## Staff Report

### **Receipt and Repackaging of Large Amounts of Heat Source Plutonium at the Los Alamos National Laboratory Plutonium Facility**

**Summary.** The National Nuclear Security Administration (NNSA) is planning a mission that involves receiving and repackaging large amounts of heat source plutonium (HS-Pu) at the Plutonium Facility (PF-4) at Los Alamos National Laboratory (LANL). NNSA recently approved an addendum to PF-4's documented safety analysis (DSA) to support this mission.

**Figure 1:** Schematic of the 9516 Type B package [3]

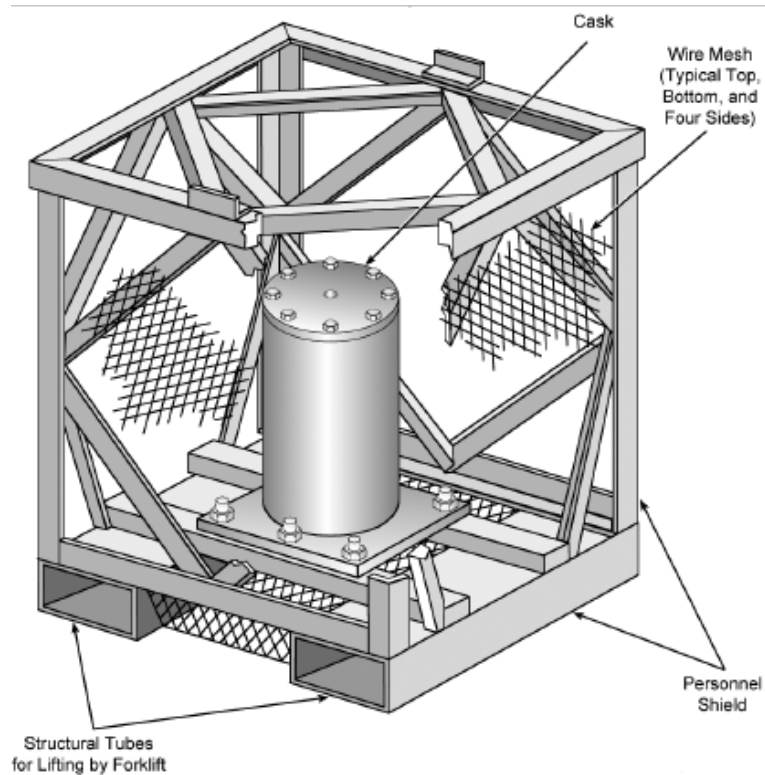
*Containment Vessel Performance*—The DSA addendum assumes that the containment vessel can withstand a fire but does not support this assumption with a rigorous evaluation. The addendum focuses on glovebox fires on the grounds that a glovebox fire would expose the containment vessel to higher air temperatures than other fire scenarios. The addendum concludes that the containment vessel would withstand exposure to those air temperatures.

However, there are other potential mechanisms for heat transfer to the confinement vessel, such as radiative heat flux from the fire and flame impingement. The DSA states that it does not consider the impact of flame impingement in a glovebox fire due to the expected transient nature of the fire. However, there are no safety controls for protecting such assumptions. Further, radiative heating and flame impingement could be more important in a room fire (i.e., outside the glovebox), which would not be as oxygen-limited as glovebox fires. Thus, the evaluation would be more persuasive if it considered radiative heating and flame impingement.

The addendum also acknowledges that the containment vessel would not withstand impact from certain equipment that could fall on it but does not identify meaningful safety controls for protecting facility workers from this hazard.
